# UNITED STATES PATENT AND TRADEMARK OFFICE

APPLICATION NO.	FILING DATE	FIRST NAMED INVENTOR	ATTORNEY DOCKET NO.	CONFIRMATION NO.
10/773,260	02/09/2004	Pierre Grasset	14612	7149

**Office Action Summary**

FIG.1

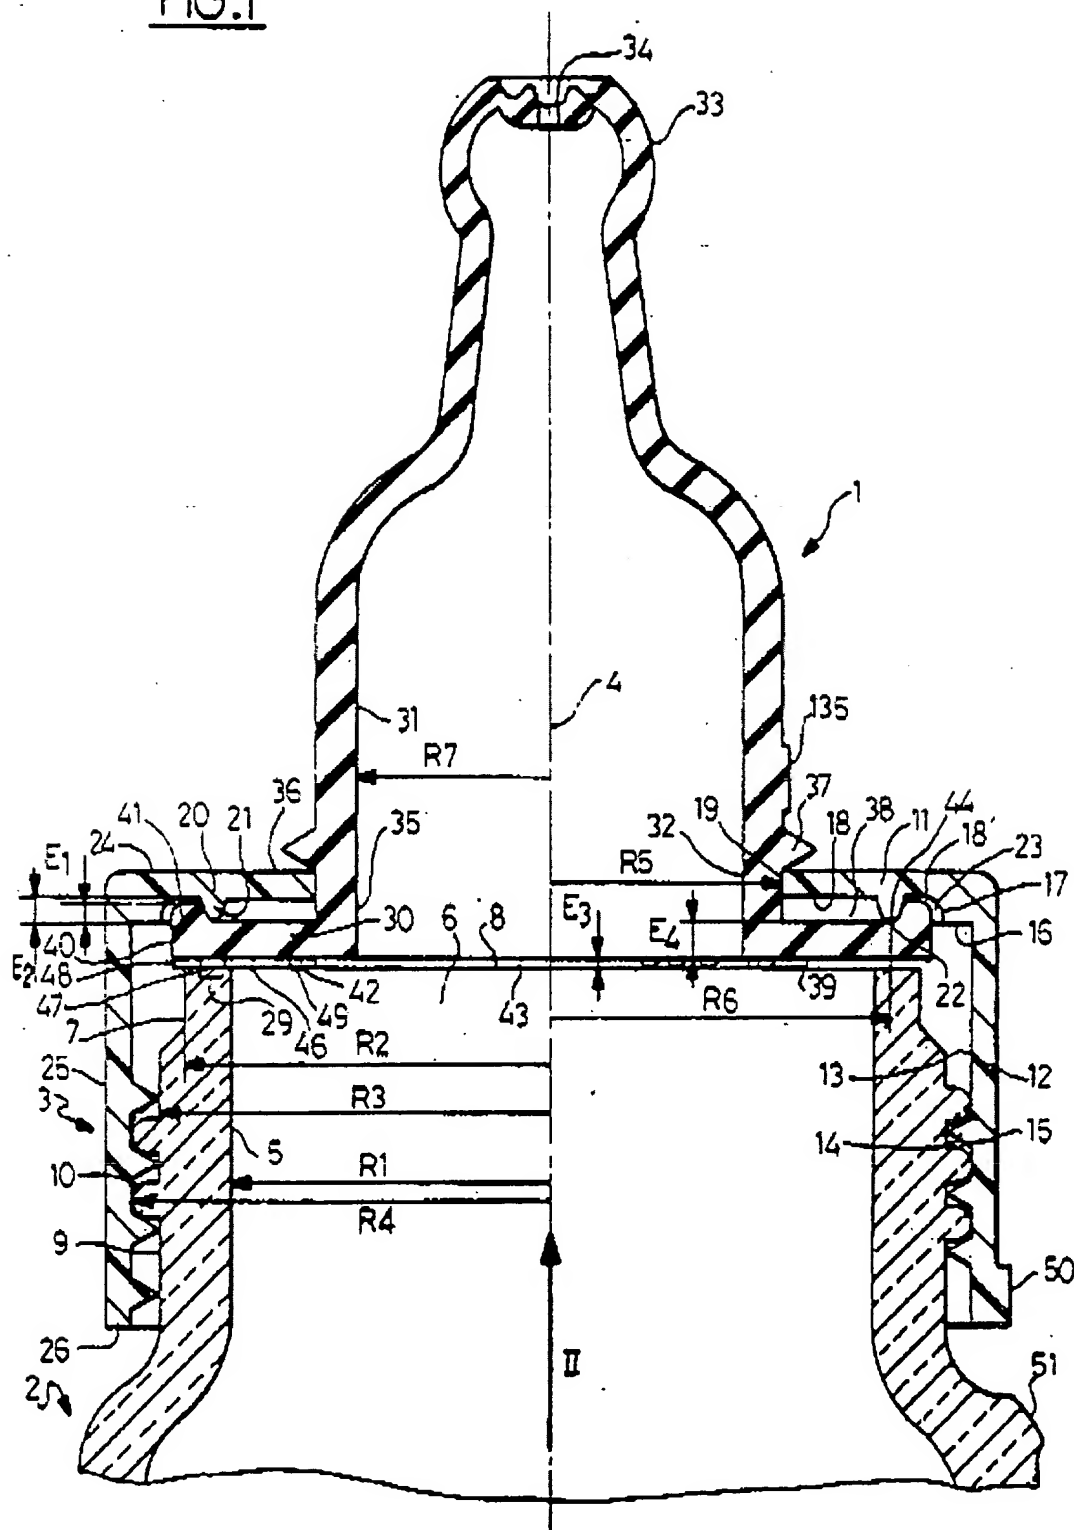
6. Claim 1 and 4-9 are rejected under 35 U.S.C. 102(b) as being anticipated by Serre 5101992.

7. Serre teaches a nursery care article comprising a tip for suction and a member surrounding the tip, and wherein a hardness of the member is greater than a hardness of the tip with the hardness of the tip being between 20 and 50 Shore A (col. 7, lines 35-40) and the hardness of the member greater than 50 Shore A (col. 6, lines 4); wherein the tip and the member are formed as a teat for a nursing bottle; wherein the member

and the tip are separately formed, the member is formed as an upper skirt of a principal part for securing the tip to a nursing bottle, the skirt having a first central opening there through thru which the tip is movable in translation along a principal axis of the tip; wherein the tip includes a base flange, the principal part further includes a ring adapted to seal the base flange against an upper neck of the nursing bottle, and the skirt being integral with the ring; wherein the ring includes an orifice for passage of an upper cylindrical portion of the tip; wherein the tip includes an integral zone for connection between the base flange and the upper cylindrical portion of the tip, the zone having a shape that is adapted to facilitate the movement in translation of the tip.

8. As to claim 4, it has been held that the term "integral" is sufficiently broad to embrace constructions united by such means as fastening and welding. *In re Hotte*, 177 USPQ 326, 328 (CCPA 1973). In the case of Serre the tip and member are integrally formed by compression.
